*Southern California Edison Company*

Subject: Docket No. 50-206  
NUREG-0737 Item II.D.1-Performance Testing of  
Relief and Safety Valves  
San Onofre Nuclear Generating Station  
Unit 1

RESPONSES TO NRC QUESTIONS ON  
PRESSURIZER RELIEF AND SAFETY VALVE TESTING  
SAN ONOFRE NUCLEAR GENERATING STATION  
UNIT 1

Figure C-6. Comparison between calculated hydrodynamic forcing functions on pipe segment L16 (RELAP5 isentropic flow case versus SCE).

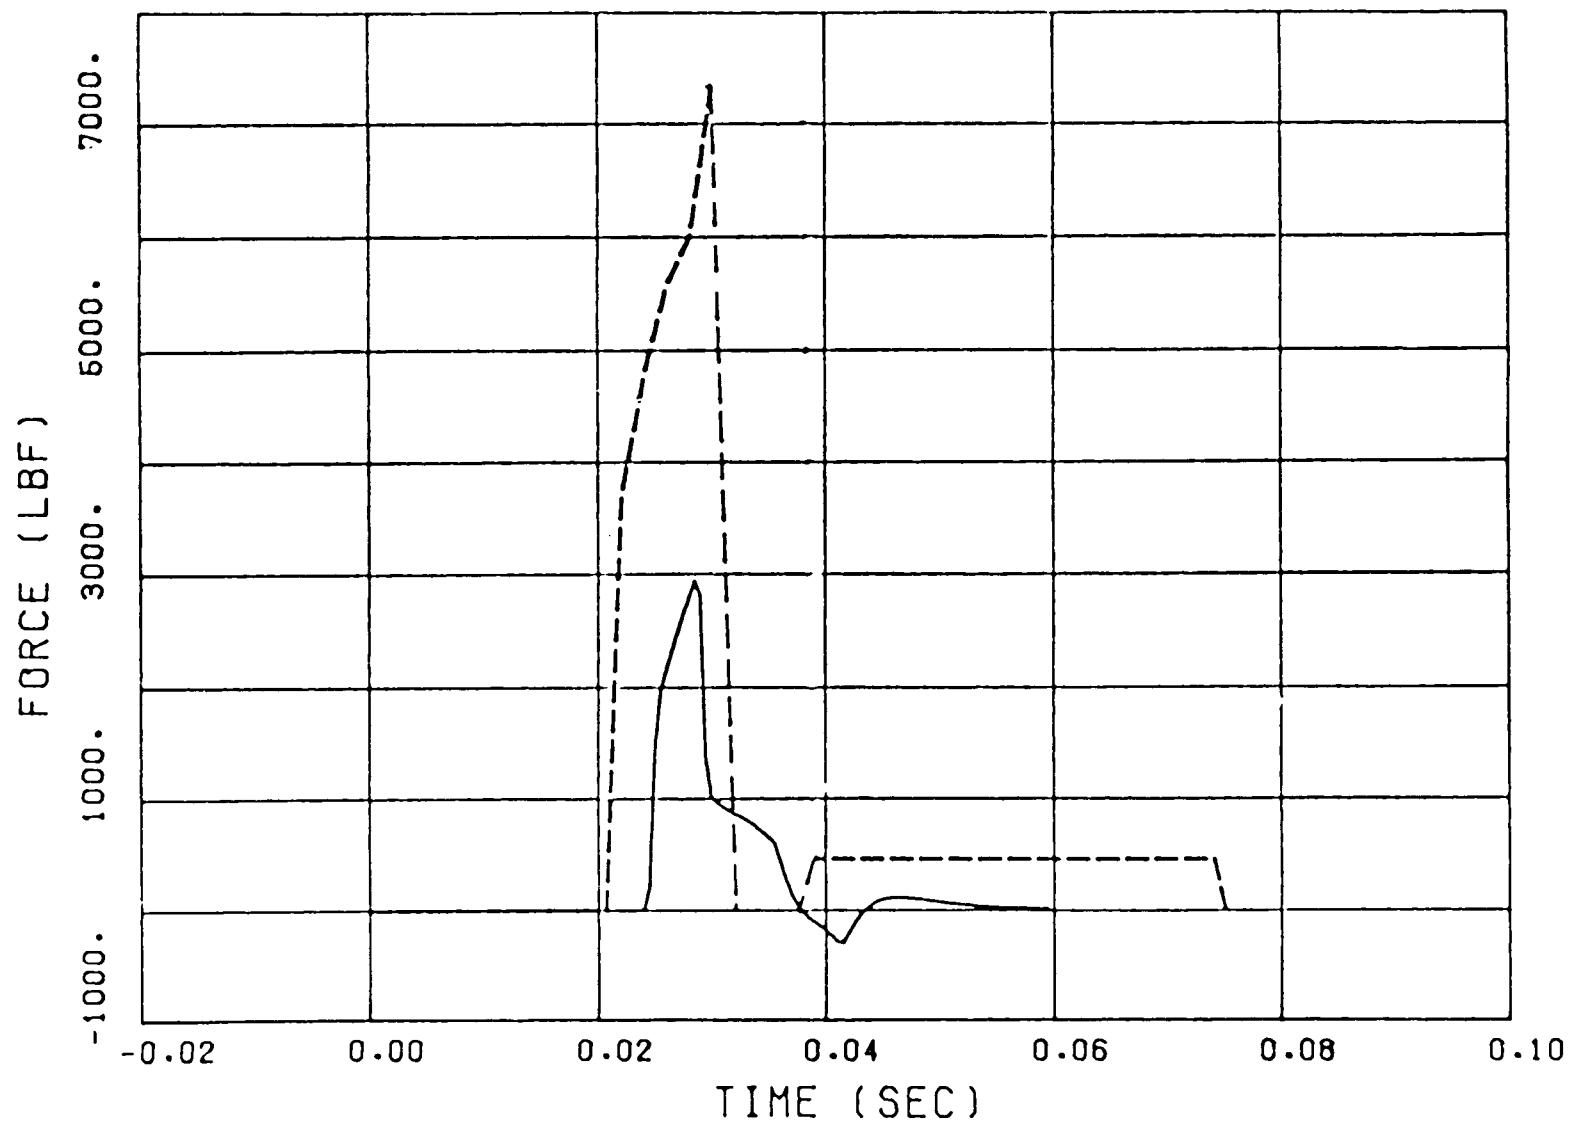
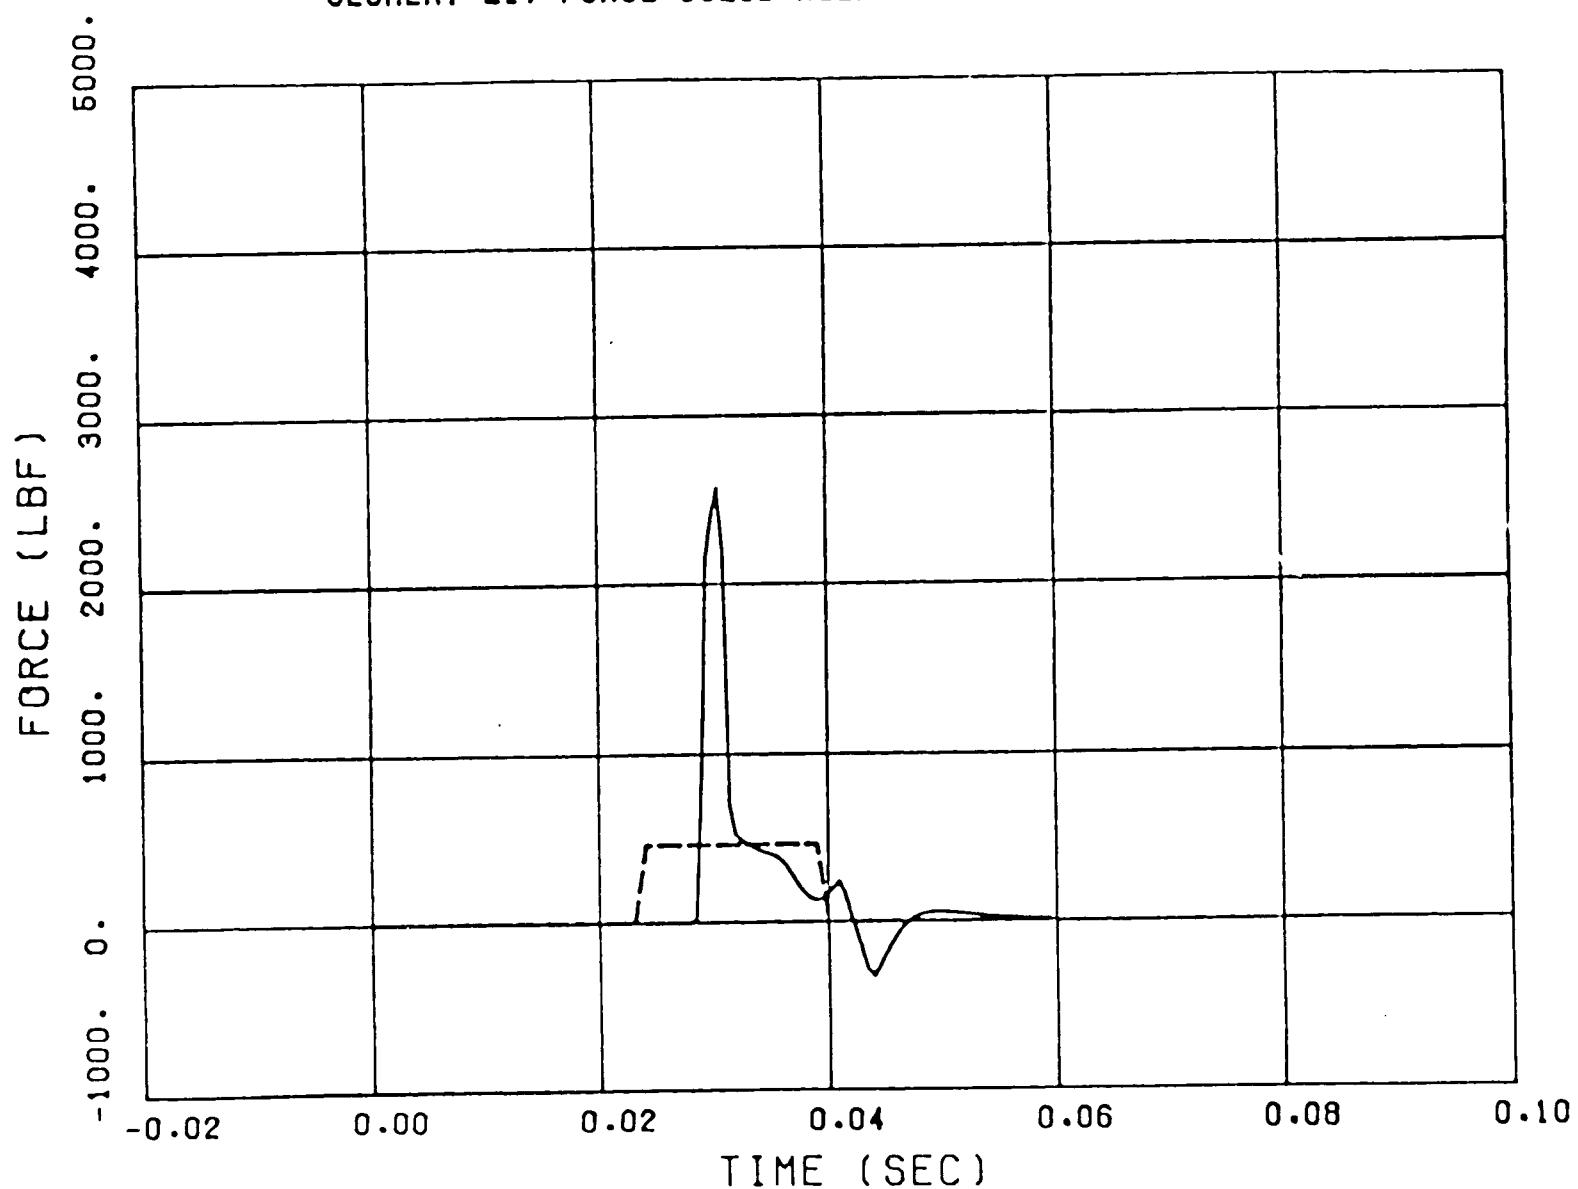
To calculate the time-dependent forcing functions acting on the piping a simplified graphical solution technique was applied. This technique is based on an ideal gas assumption. High pressure steam, though, is not an ideal gas. How well the technique applies to PWR conditions has not been demonstrated. The authors of the paper on this technique did compare calculations with test data for steam at 995 psia and obtained a good comparison. Provide further comparisons or verification to show the validity of this technique for PWR steam discharges.

Intermountain Technologies, Inc. (ITI), in Idaho Falls, was asked to evaluate independently the hydrodynamic loads due to valve actuation on the discharge piping using RELAP 5/MOD 1 Code. The analysis was for saturated steam upstream of the safety valves without assuming an ideal gas. The results of ITI's report are shown in Figures C-1 through C-7. These results demonstrate that SCE's results using simplified graphic solutions based on an ideal-gas assumption show good comparison in force characteristics and conservative data in force magnitudes. The discrepancy in Figure C-7 is judged not to be of any significant consequence because of the significant margins in all other pipe segments.
